# ADDENDUM No. 1

RFP No. 22-50

## Russell Street Improvements

SHEET NO. 11 OF 22

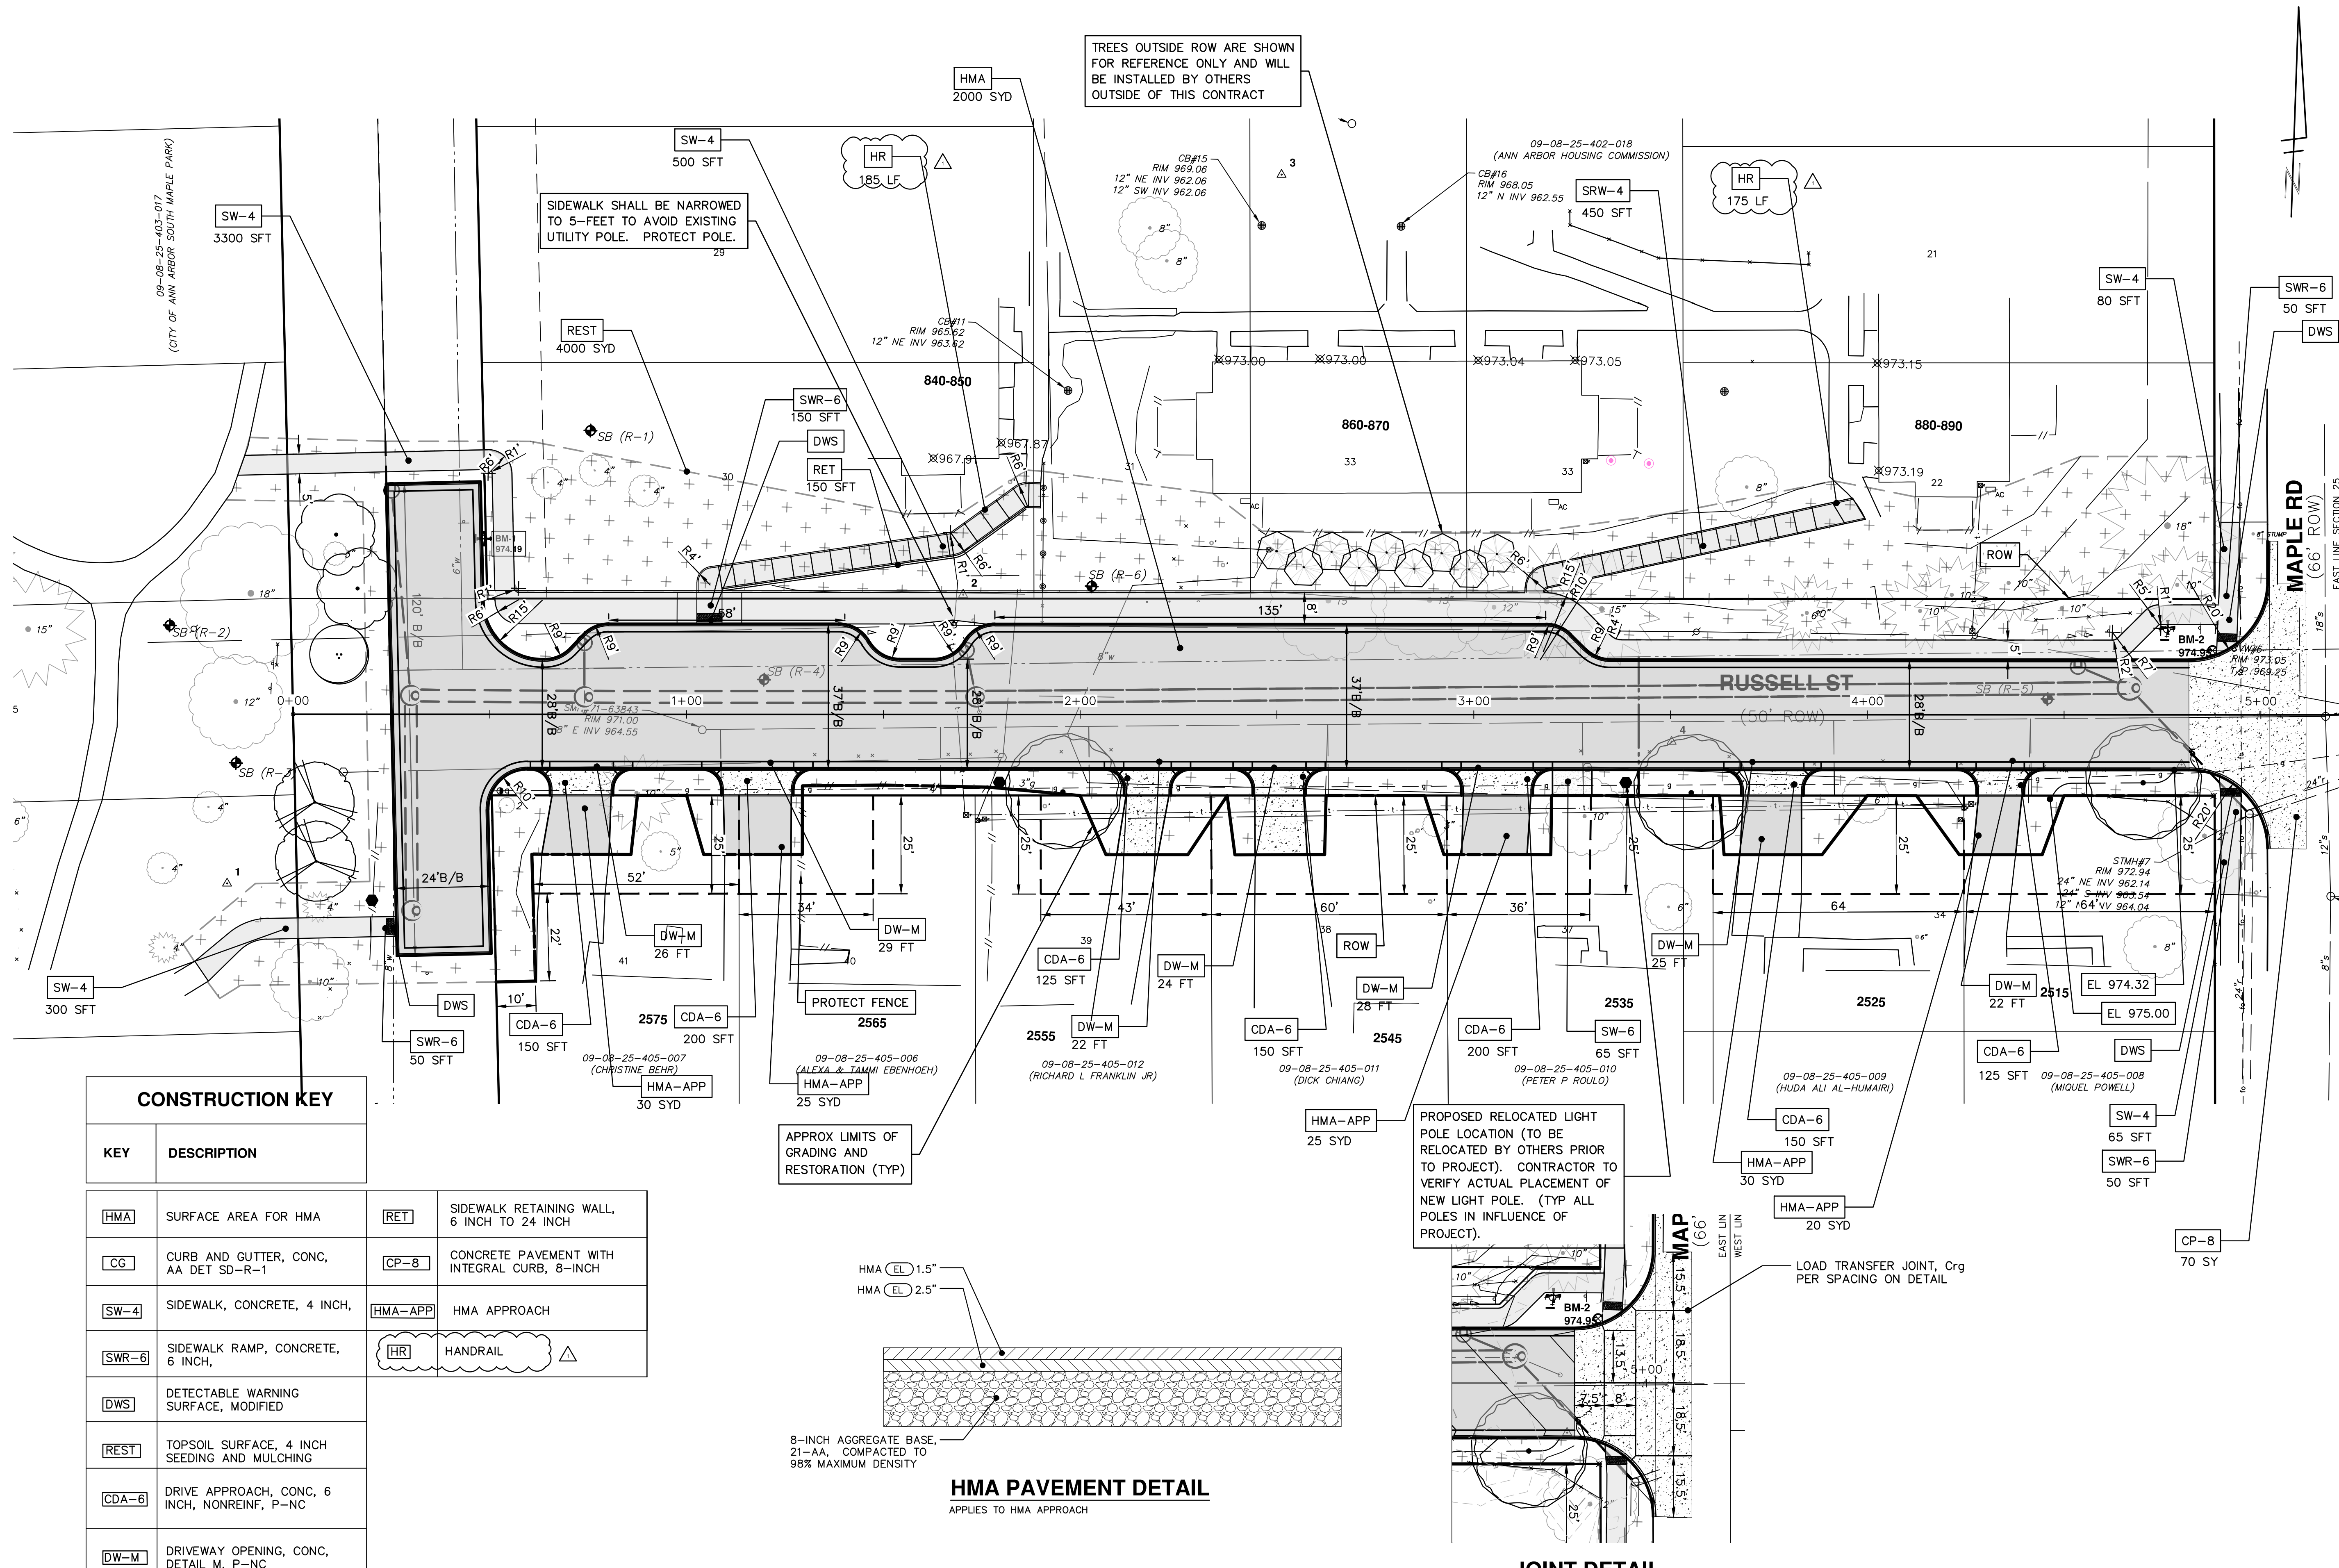
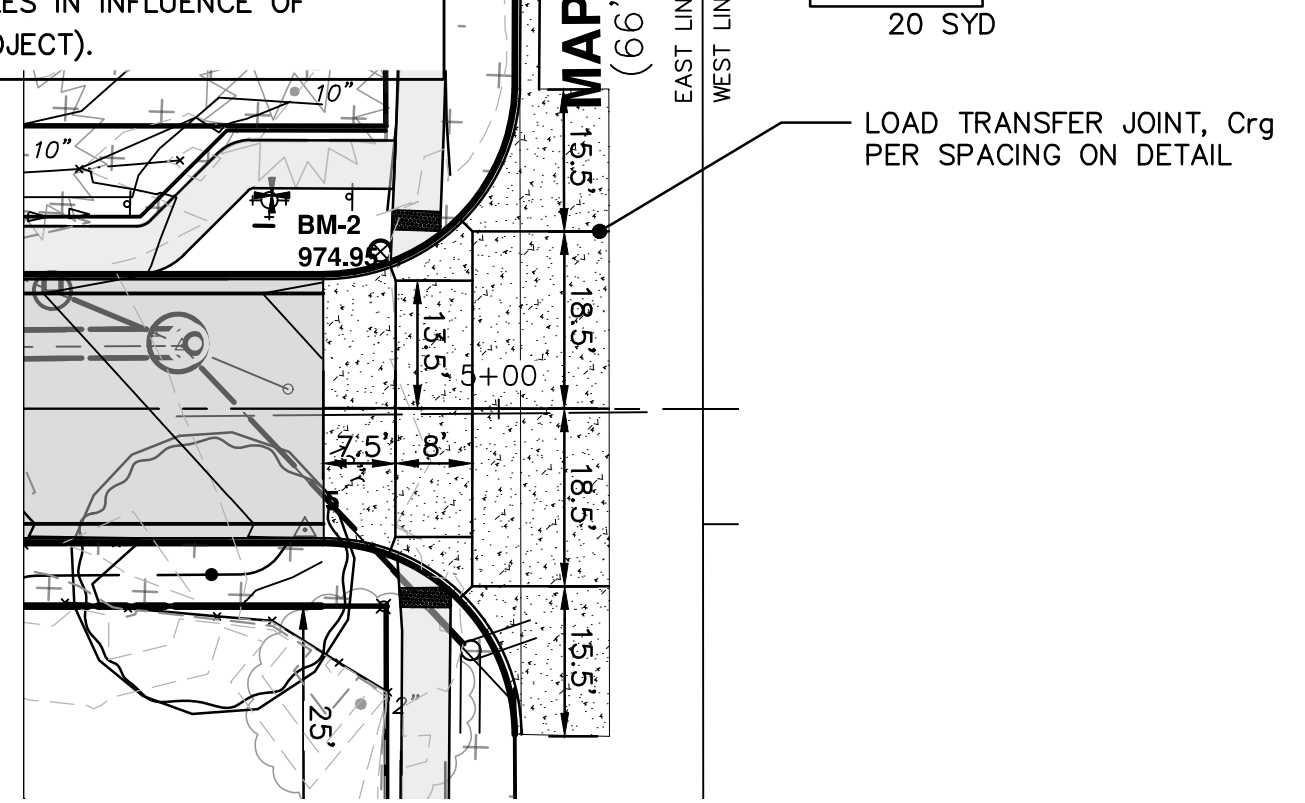
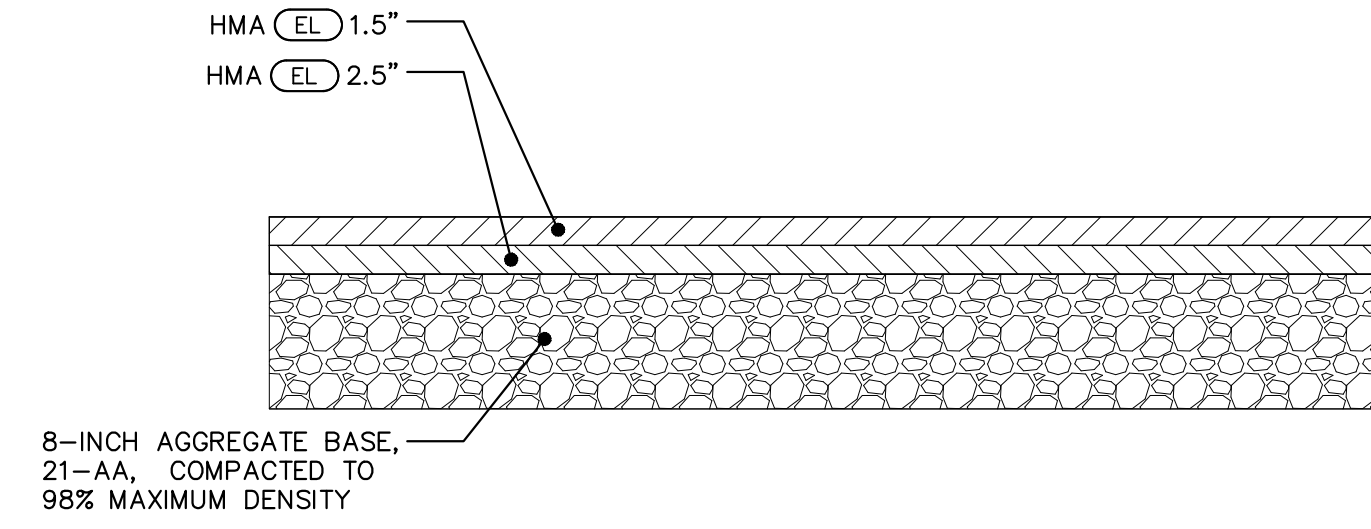
Section/Page(s)	Change
Pages 2-4	The Bid Form has been amended to reflect the modifications of this Addendum No. 1. Item number 254, Handrail, Lump Sum has been added.
Pages 5-6 + Plans	The project is adding handrail to the north side ramps to Maple Meadows as shown in the attached drawings (Plan Sheet 8A, Plan Sheet 11), detailed specification dated 06-02-2022, and Bid Form.
Plans Only	The controlled stormwater outlet structure detail has been corrected to show the proper Fluidic Cone outlet size of 9-inches (Plan Sheet 19, dated 06-02-2022). The Fluidic Cone model remains the same (FC-9).
